Envision Construction Design, Inc  
Change Order Request #05

Project: Chabot Las Positas Community College  
5860 Owens Drive, 3rd Floor  
Pleasanton, CA 94588

### Change Order

<b>PROJECT:</b> SRAC-Chabot Las Positas TI		<b>JOB #:</b> 20-460	
<b>COMPANY:</b> Hereld & Ayres Architects		<b>COMPANY:</b> Envision Construction & Design Inc.	
<b>TO:</b> Kurt Hereld	<b>FROM:</b> John Wood 925-719-4111		
<b>PHONE:</b> 925-600-1166	<b>PHONE:</b> 925-560-9906		
<b>FAX:</b> N/A	<b>FAX:</b> 925-560-9907

| <input type="checkbox"/> INTERPRETATION OF REQUIREMENTS   | <input checked="" type="checkbox"/> DRAWING RE: <u>A2.7</u> |

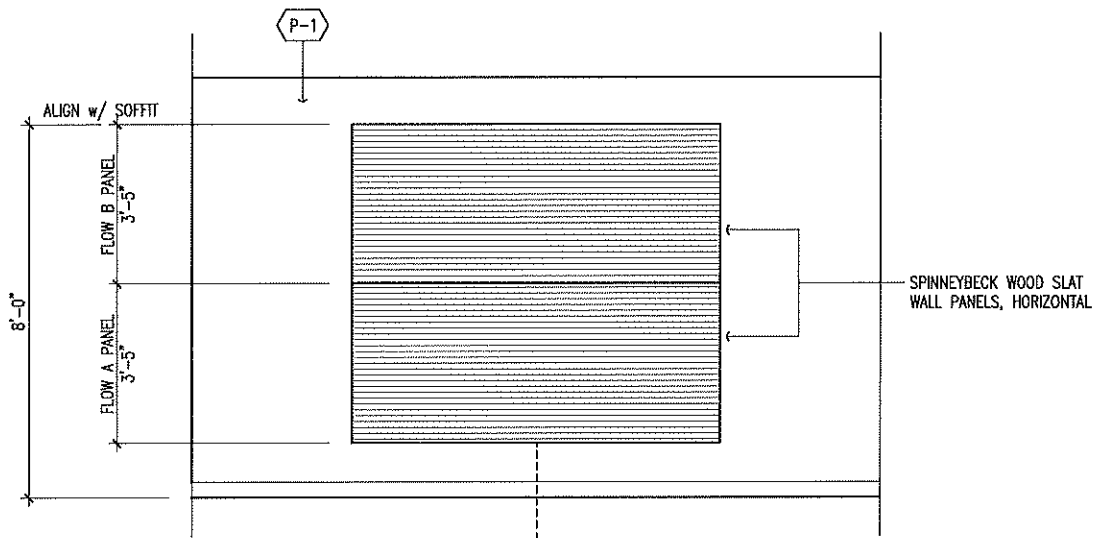
I have been searching for WD-1, The spec is missing info on the finish legend. There are many wall panels listed under this category. We need more information. We need specific product details. Addendum #6 does not clarify exact product. Please advise.

John,  
See the attached interior elevations showing the application of the Spinneybeck product at the 3  
locations.  
thanks  
-kurt

**Z** HALL D308 & D313  
 $3/8"=1'-0"$

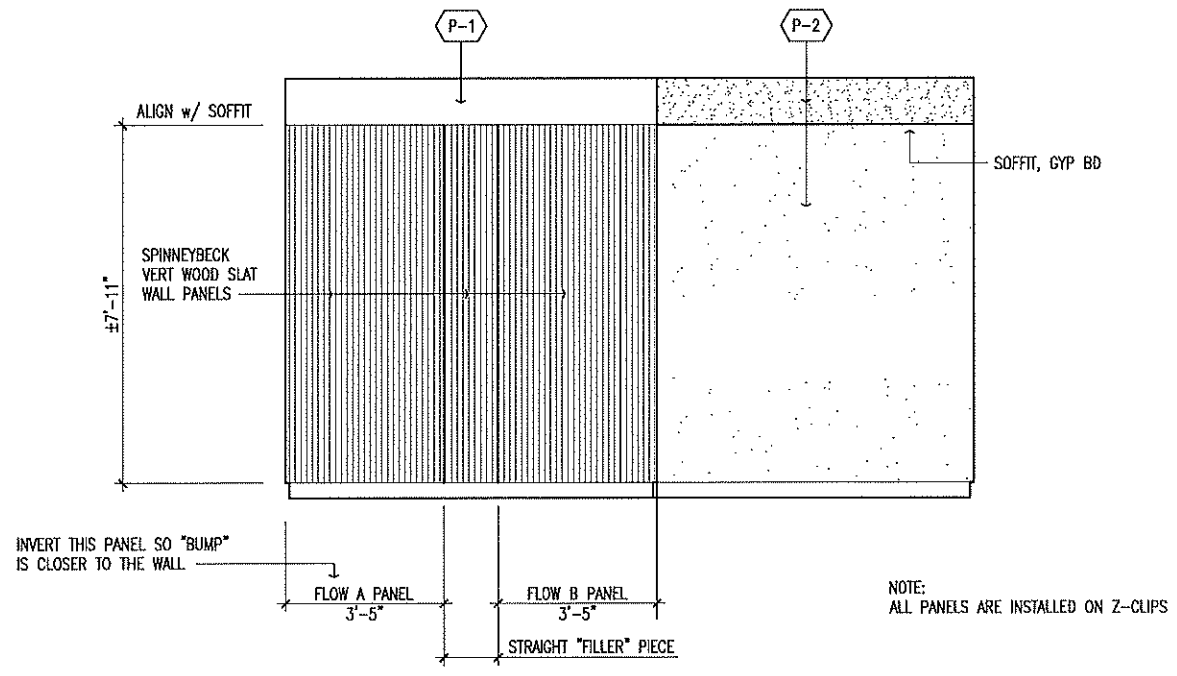
AT HALL D308, MOUNT ON WALL SHARED BY HALL D308 & OSHA TRAINING D303; CENTER ON RESTROOM DOORS (RESTROOMS A302 & A303)

AT HALL D313, MOUNT ON WALL SHARED BY HALL D313 & RESTROOMS A302 & A303; CENTER ON HALL WINDOW AT CLASSROOM 5, ROOM D317

NOTE:  
 ALL PANELS ARE INSTALLED ON Z-CLIPS

10-23-20  
 CHABOT-LAS POSITAS CCD TI  
 ADDITIONAL CONDUIT AND  
 ELECTRICAL

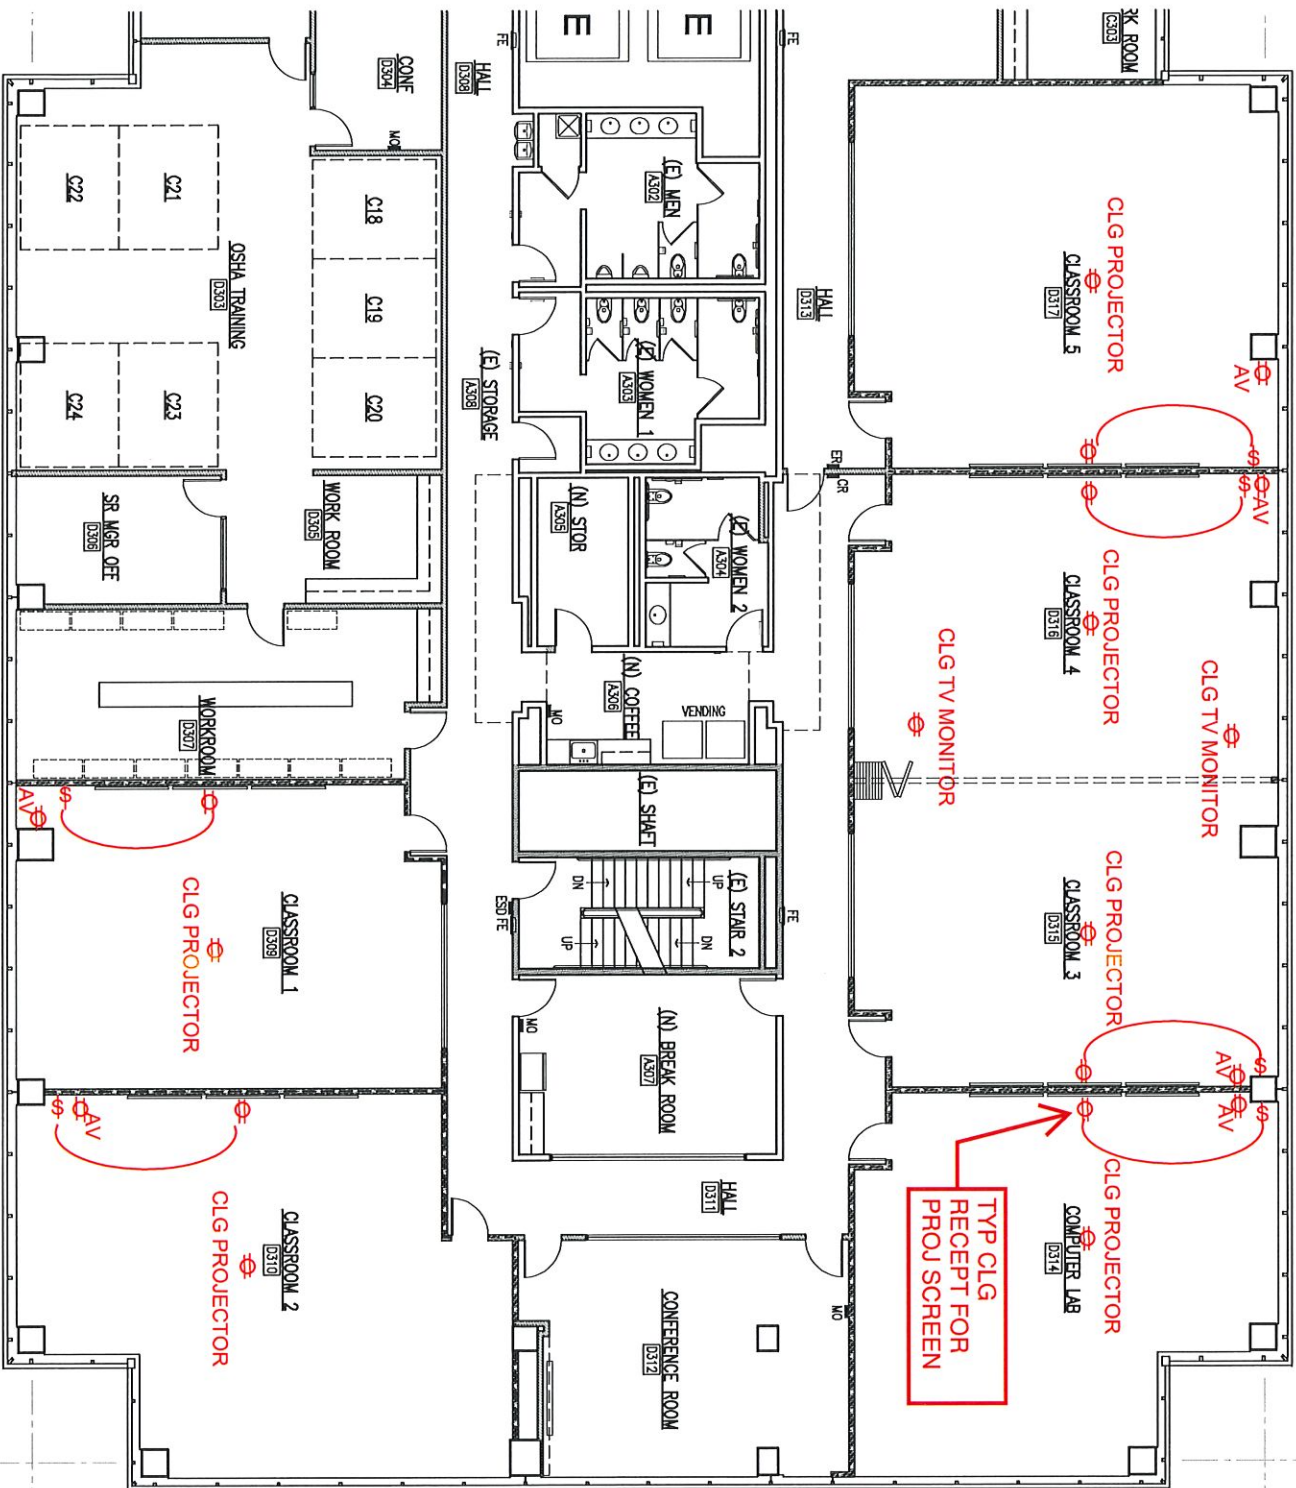
1. Sheet E3.0 does not show power for the Projectors or Projector Screens. Please provide Direction.
2. Per our conversation you need use to add power for 2 TV Monitors at the Folding Partition wall in Class Rooms 3 & 4. Please provide (Locations, Height, Mounting Bracket Type, Electrical & Data requirements).

John,  
We have already coordinated this with you but I just wanted to close out this RFI.  
-kurt

10-12-20  
 CLPCCD Tenant Improvement  
 Floor Plan - CARD READERS

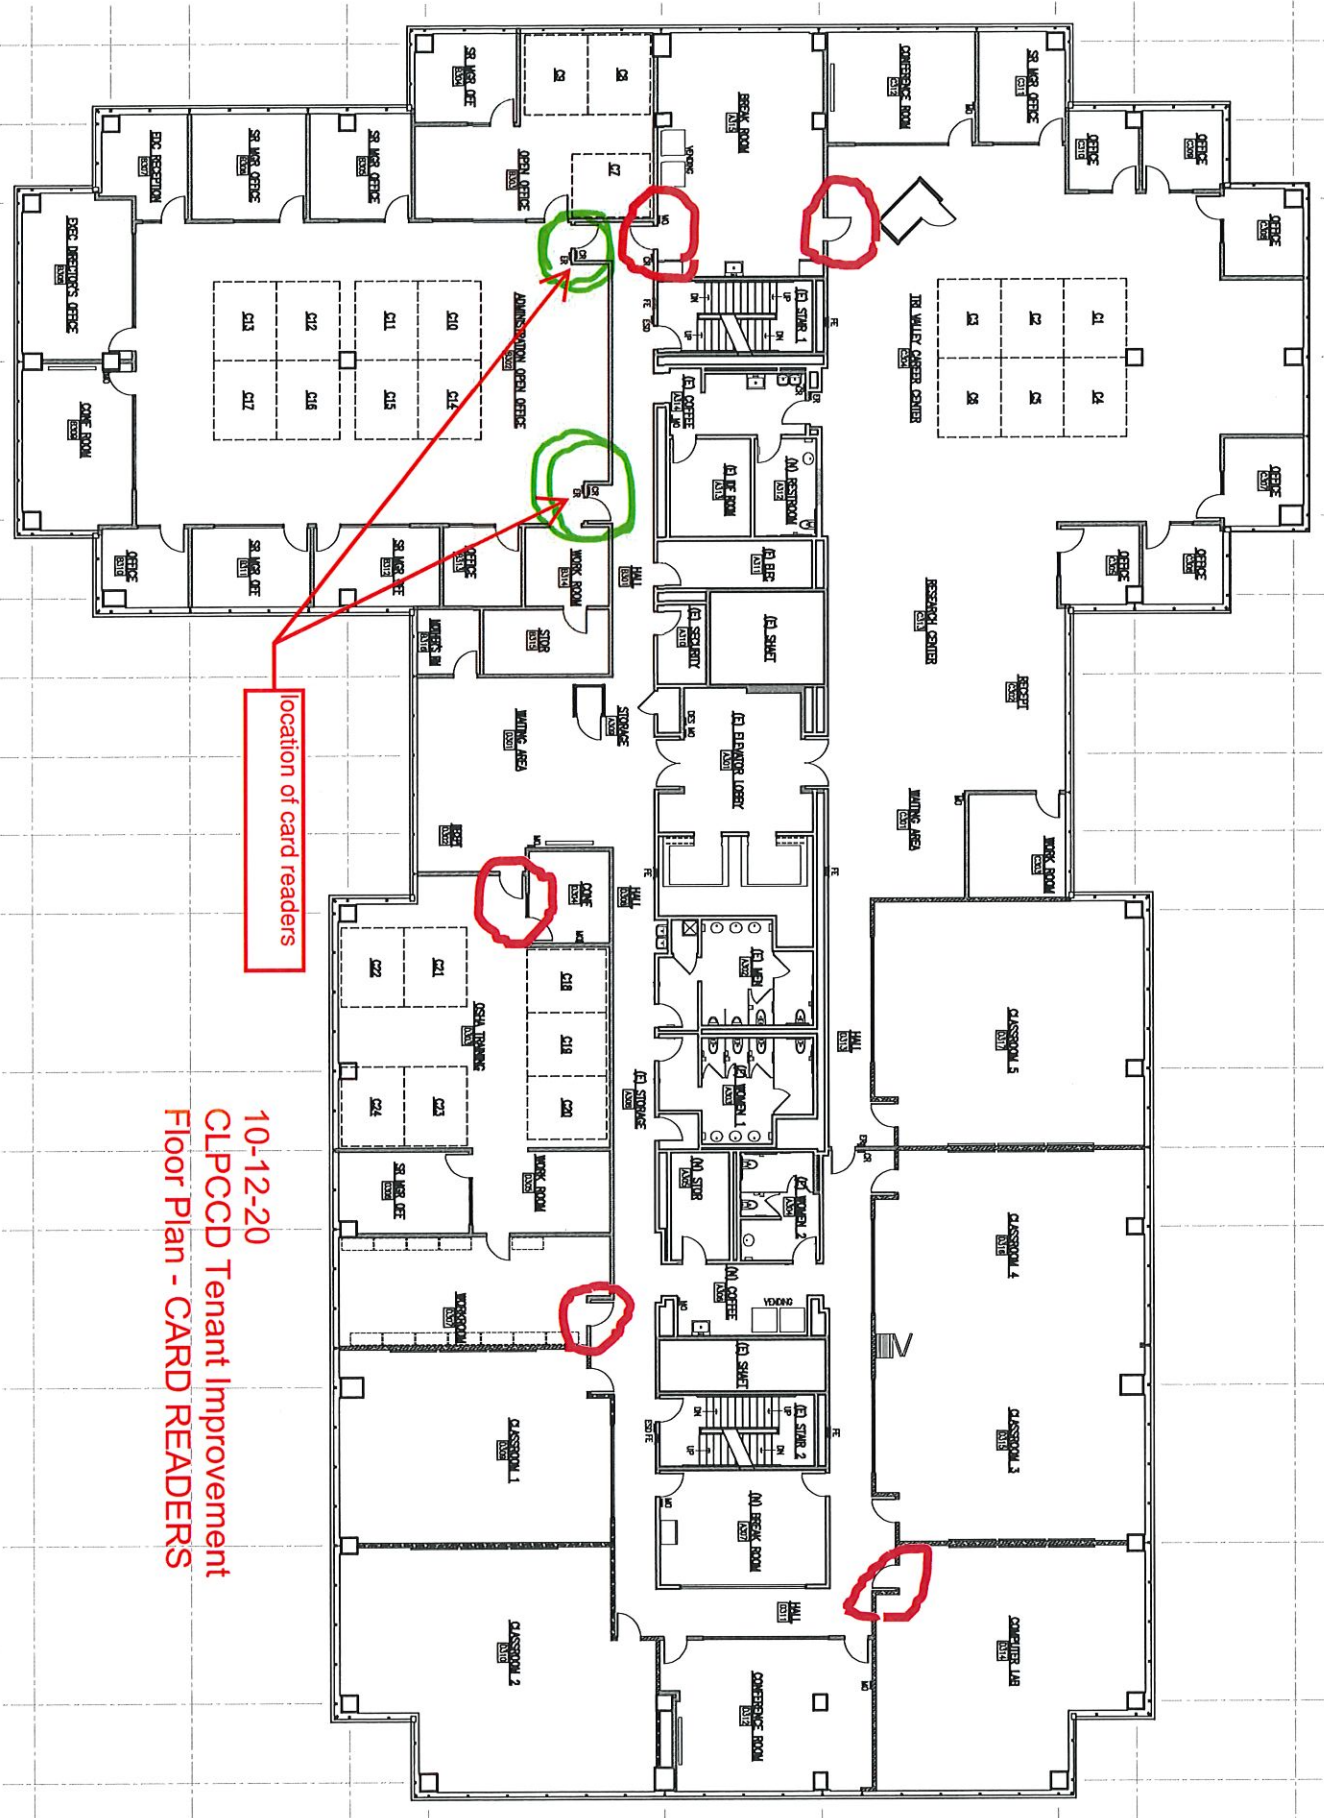
location of card readers
